Docket Item # 5
BAR CASE # 2012-0149

BAR Meeting
June 6, 2012

ISSUE: Alterations
APPLICANT: Greg and Nancy Woodford by Patrick Camus
LOCATION: 212 South Pitt Street
ZONE: RM / Residential

CASE BAR2012-0149

PERFORMANCE DIVIDED LITES FOR WOOD WINDOWS & DOORS

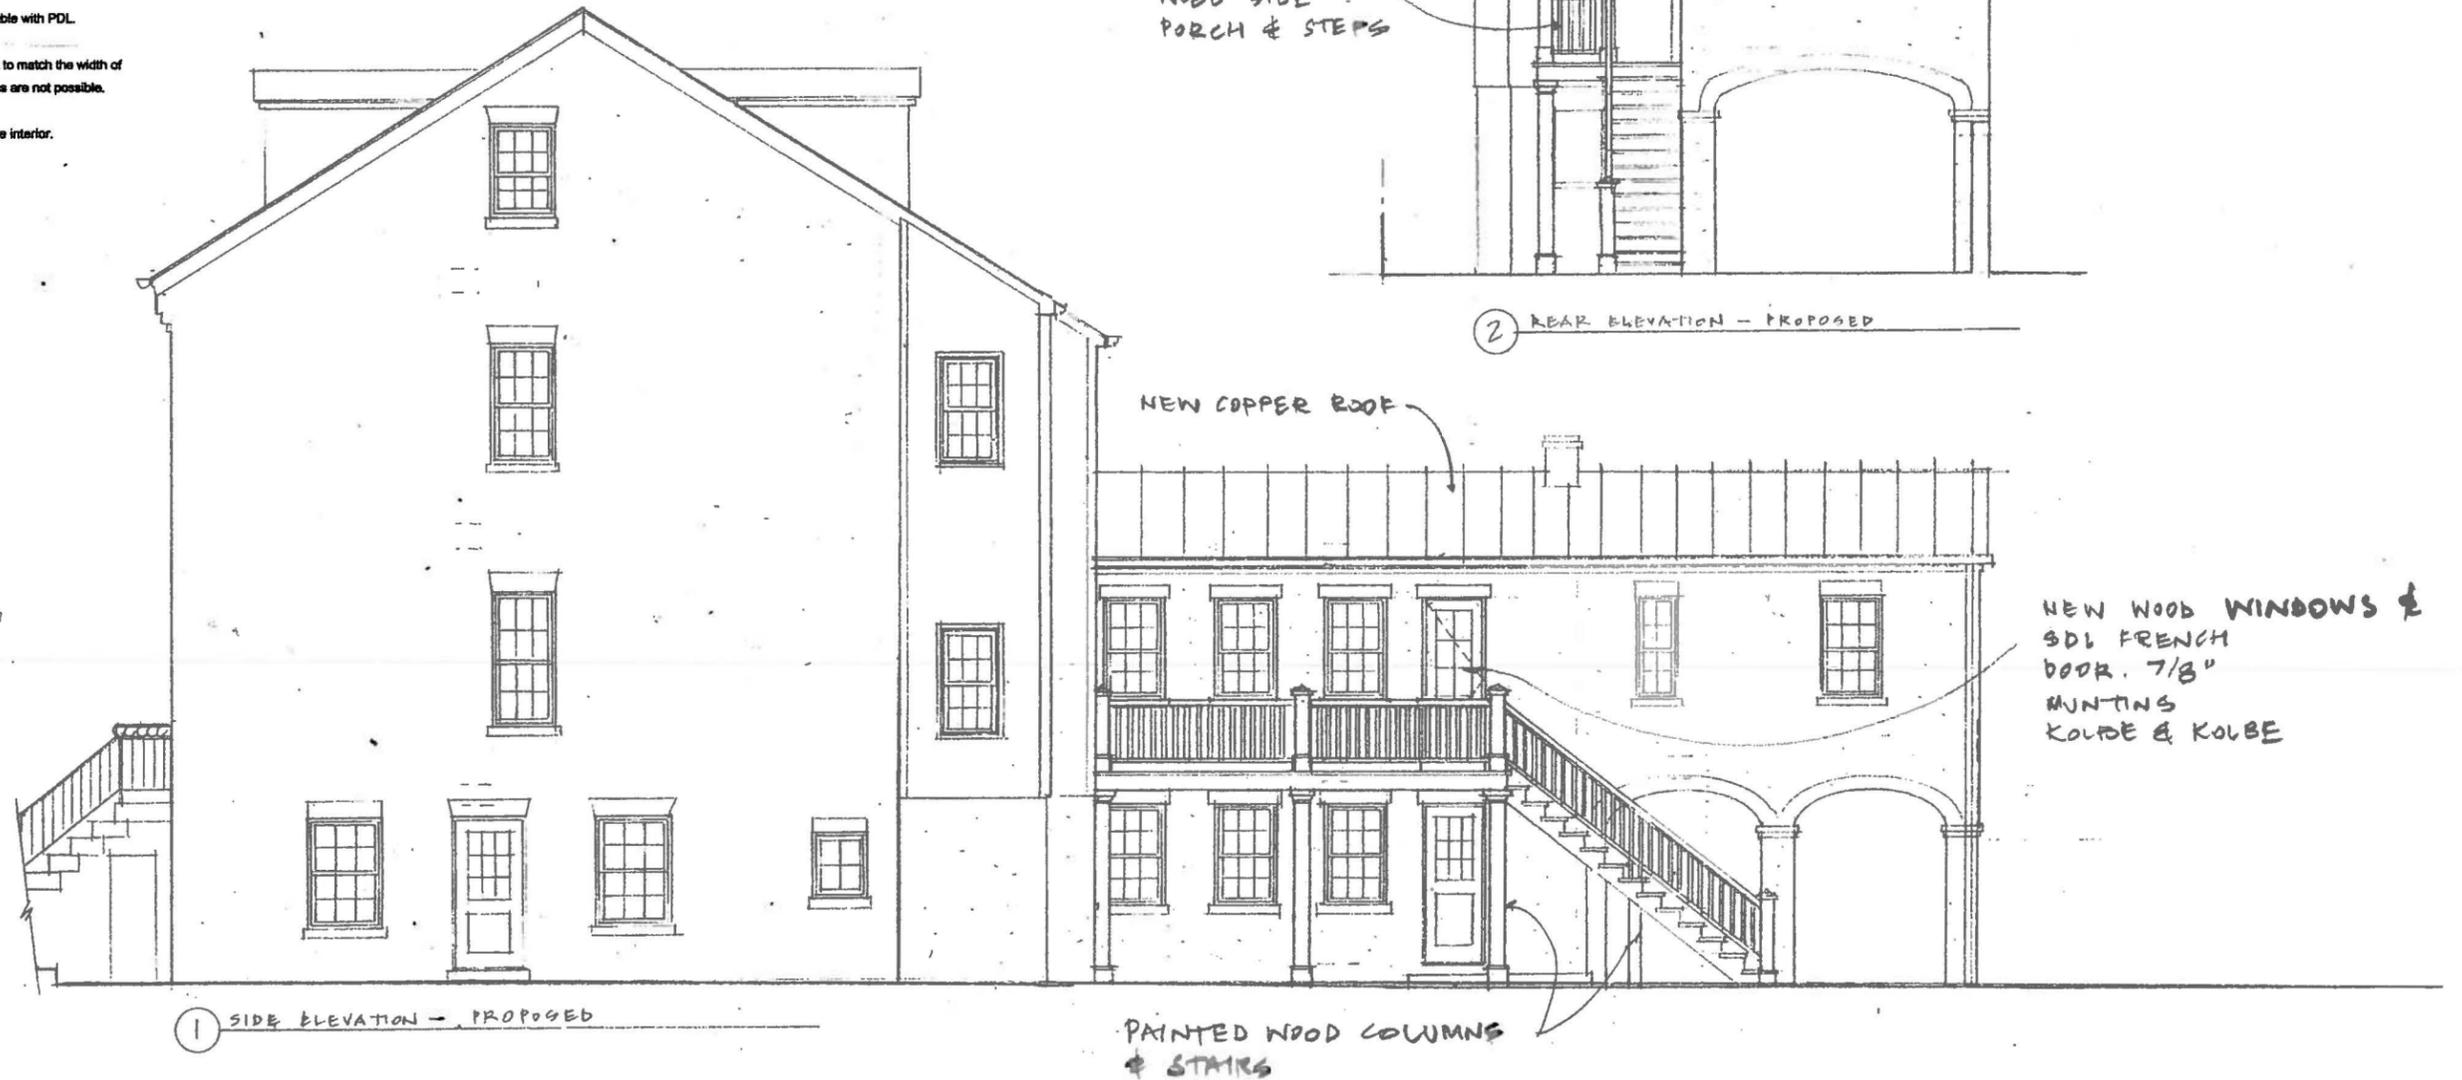
1. Staff recommends **approval** of the Certificate of Appropriateness for the proposed alterations with the condition that:
 - a. The muntins on all of the replacement windows be 5/8" wide and not 7/8" wide as proposed by the applicant, and;
2. Staff recommends **denial** of the request for:
 - a. A copper roof on the rear ell, and
 - b. The two simulated divided light replacement windows on the north elevation of the original portion of the rear ell.

The applicant also proposes to remove the existing slate roof on the rear ell and install a new copper roof, as well as replace the existing true divided light wood windows on the ell with simulated divided wood windows. The new Kolbe & Kolbe windows will have a six-over-six configuration with 7/8" muntins with a beveled profile.
